GULFEAGLE  
SUPPLY

LANDSCAPE  
PLAN

MVE PROJECT 61078  
MVE DRAWING -DEV-LP

# Landscape\_v2-redline.pdf Markup Summary

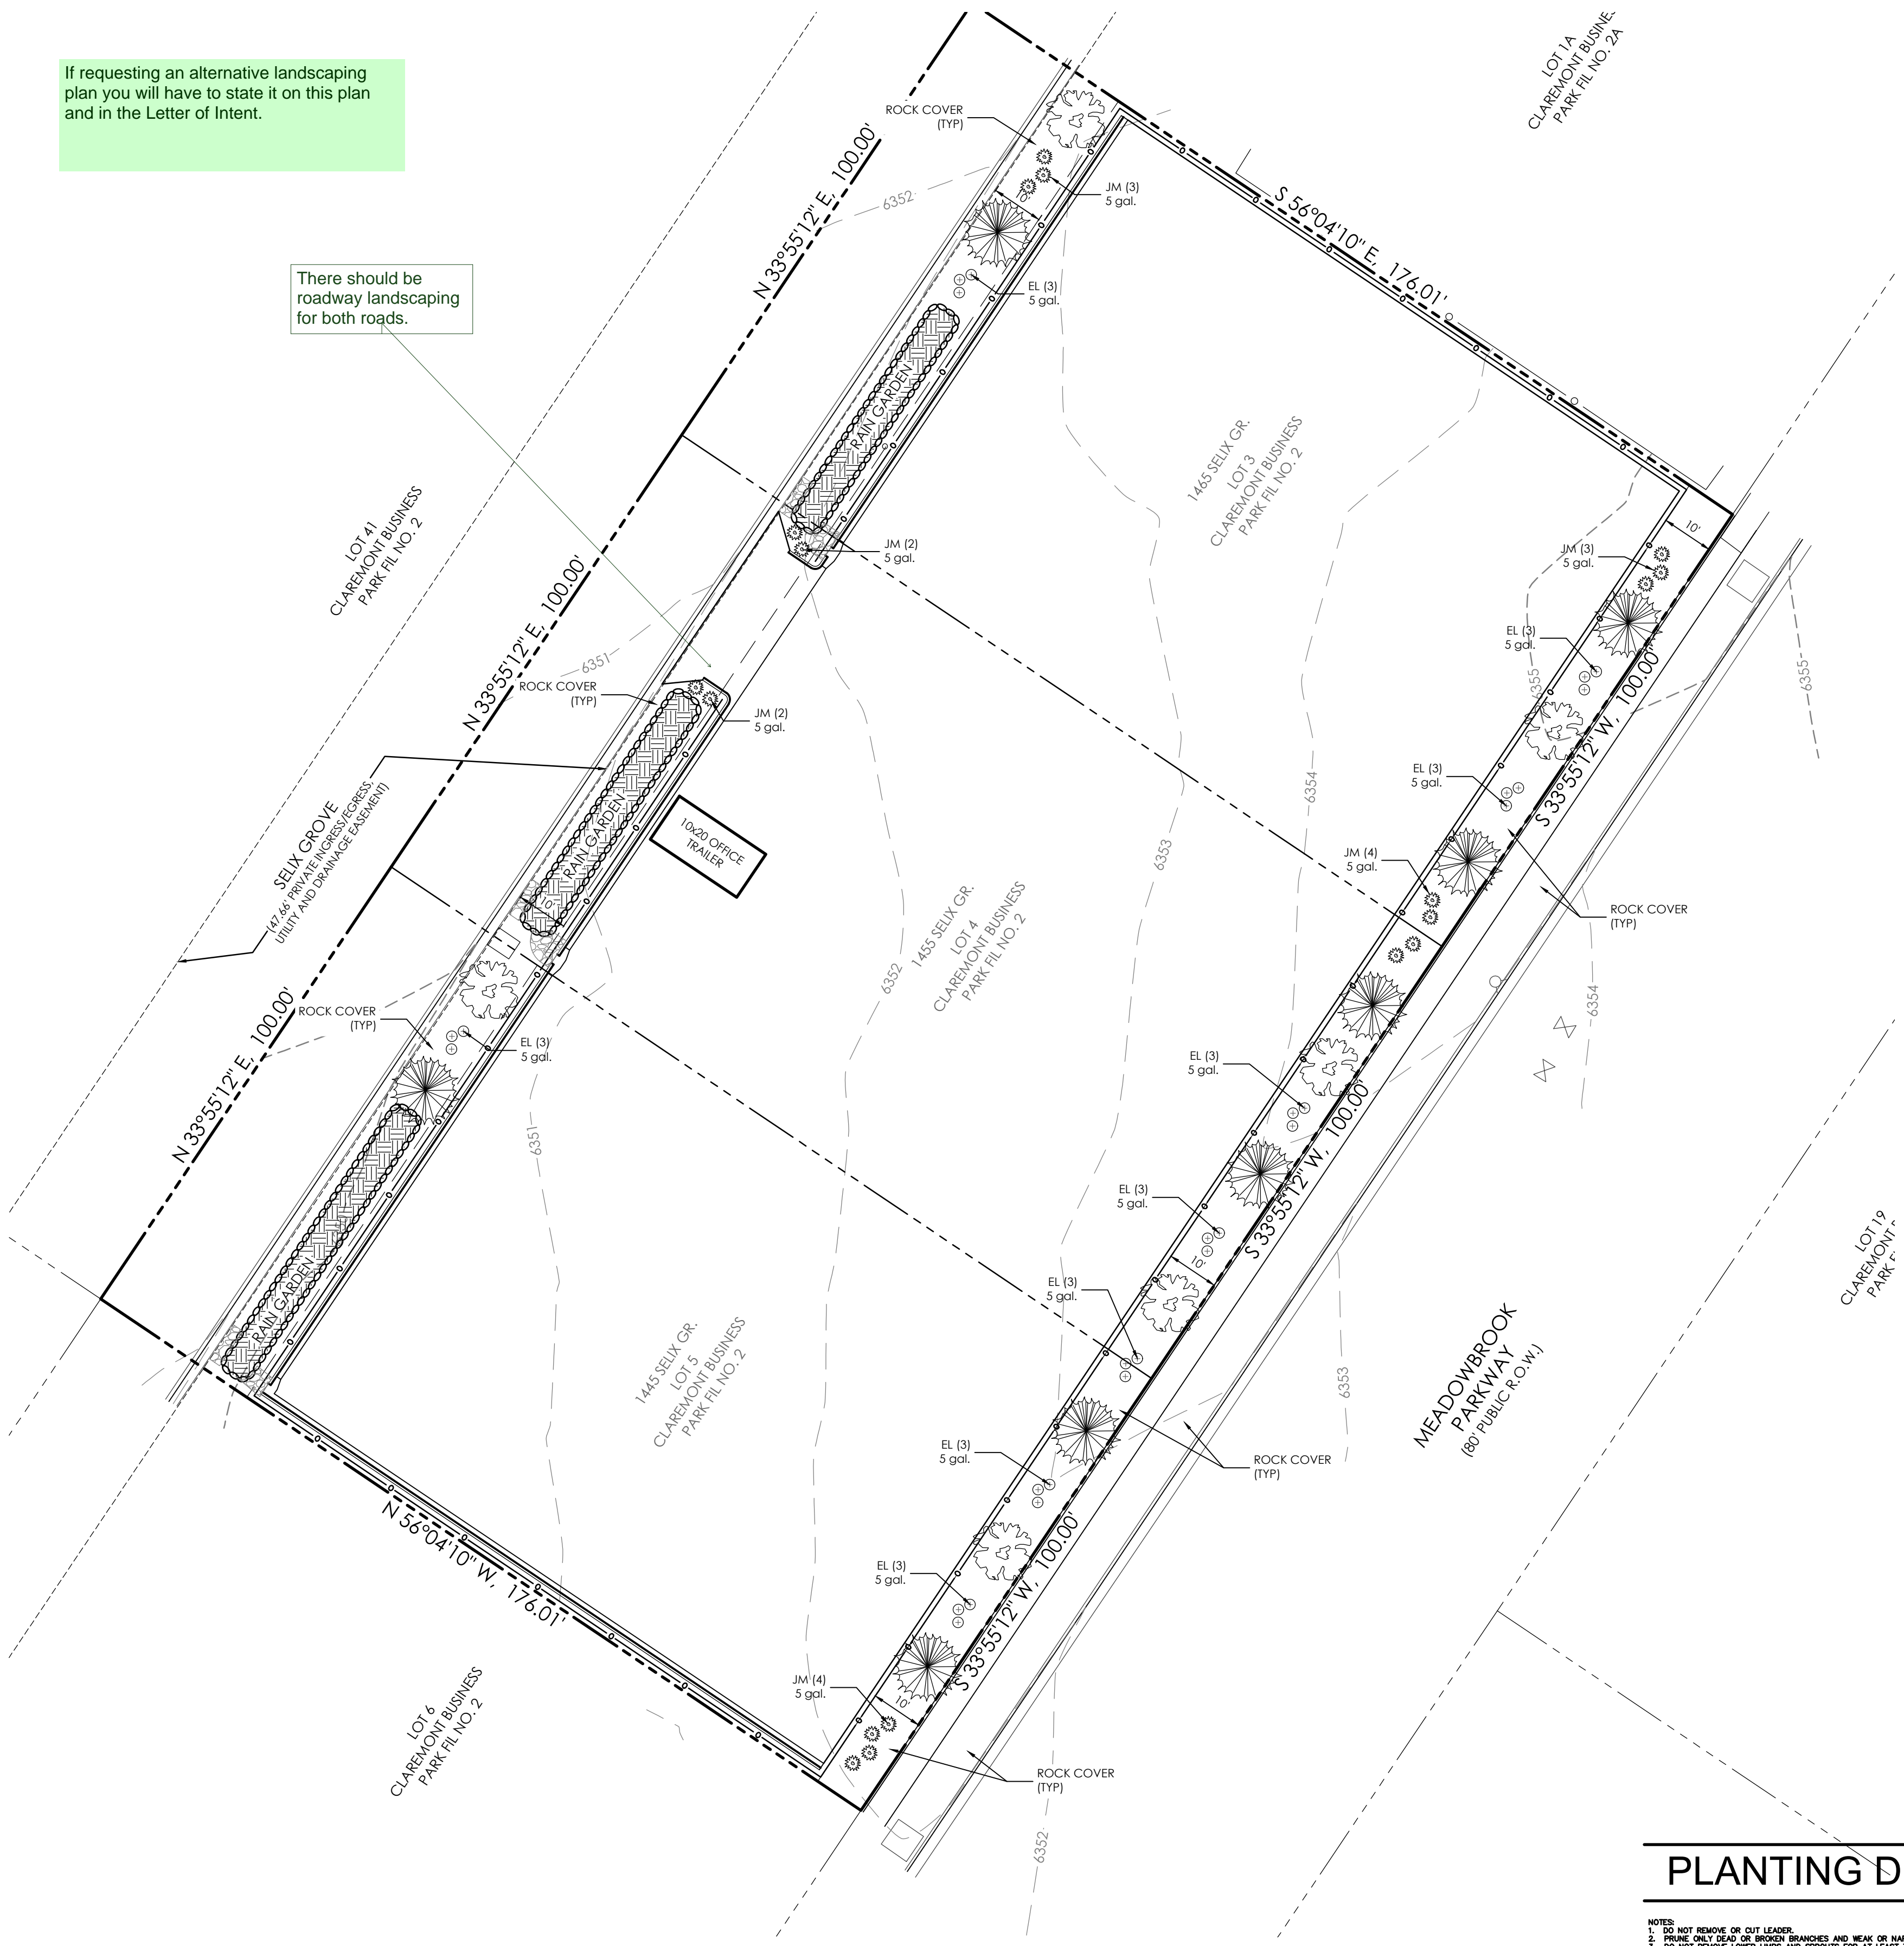
If requesting an alternative landscaping plan you will have to state it on this plan and in the Letter of Intent.

There should be roadway landscaping for both roads.
